UNITED STATES PATENT AND TRADEMARK OFFICE

APPLICATION NO.	FILING DATE	FIRST NAMED INVENTOR	ATTORNEY DOCKET NO.	CONFIRMATION NO.
10/733,568	12/12/2003	Satoshi Kojima	03500.017762.	8616
5514 7590 12/20/2006 FITZPATRICK CELLA HARPER & SCINTO 30 ROCKEFELLER PLAZA NEW YORK, NY 10112			EXAMINER DOTE, JANIS L	
			ART UNIT 1756	PAPER NUMBER
SHORTENED STATUTORY PERIOD OF RESPONSE		MAIL DATE	DELIVERY MODE	
2 MONTHS		12/20/2006	PAPER

Office Action Summary	Application No. 10/733,568	Applicant(s) KOJIMA ET AL.	
	Examiner Janis L. Dote	Art Unit 1756

FIG. 1

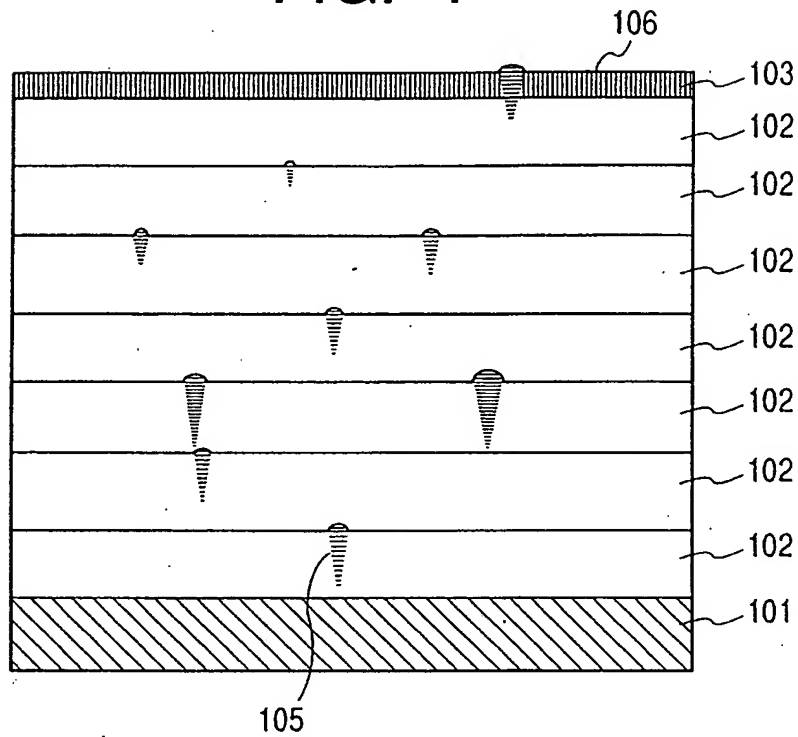
DO NOT
ENTER BOTH
REPLACEMENT SHEETS
NOT ACCEPTABLE
D. D. D.
12/14/06

FIG. 2 PRIOR ART

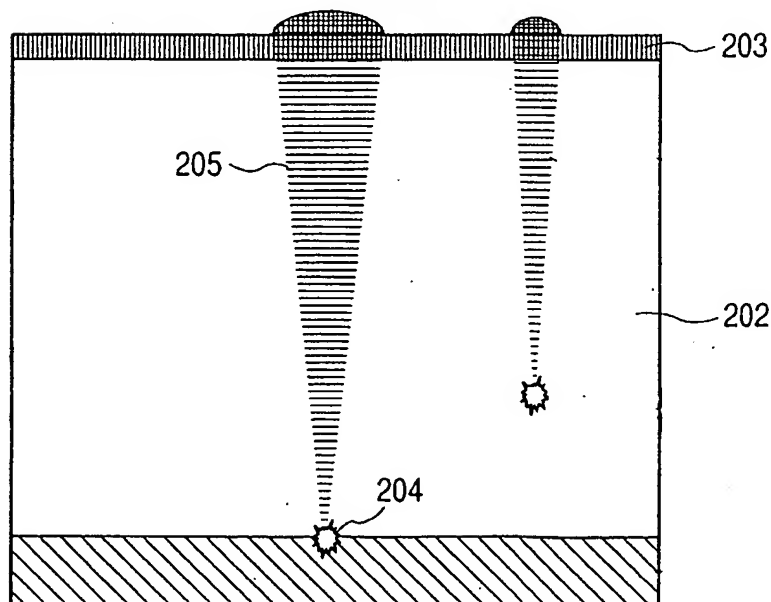
4. The replacement drawing sheets filed on Jul. 31, 2006, are not acceptable because they did not address all of the objections to Fig. 2 set forth in the office action mailed on May 15, 2006, paragraph 2. The replacement drawing sheet of

Fig. 2 includes the reference characters **204** and **205**, which are not mentioned in the description.

In Fig. 2, the reference characters **201**, **204**, and **205**. See the instant specification, page 4.

Figure 2 should be designated by a legend such as --Prior Art-- because only that which is old is illustrated. See the instant specification, page 4, lines 11-14, which identifies the drawing as "an example of protuberances in a conventional electrophotographic photosensitive member." See MPEP § 608.02(g).

Corrected drawing sheets in compliance with 37 CFR 1.121(d), or amendment to the specification to add the reference character(s) in the description in compliance with 37 CFR 1.121(b) are required in reply to the Office action to avoid abandonment of the application. Any amended replacement drawing sheet should include all of the figures appearing on the immediate prior version of the sheet, even if only one figure is being amended. Each drawing sheet submitted after the filing date of an application must be labeled in the top margin as either "Replacement Sheet" or "New Sheet" pursuant to 37 CFR 1.121(d). If the changes are not accepted by the examiner, the applicant will be notified and informed of any required corrective action in the next Office action. The objection to the drawings will not be held in abeyance.

Corrected drawings in compliance with 37 CFR 1.121(d) are required in reply to the Office action to avoid abandonment of the application. The replacement sheet(s) should be labeled "Replacement Sheet" in the page header (as per 37 CFR 1.84(c)) so as not to obstruct any portion of the drawing figures. If the changes are not accepted by the examiner, the applicant will be notified and informed of any required corrective action in the next Office action. The objection to the drawings will not be held in abeyance.
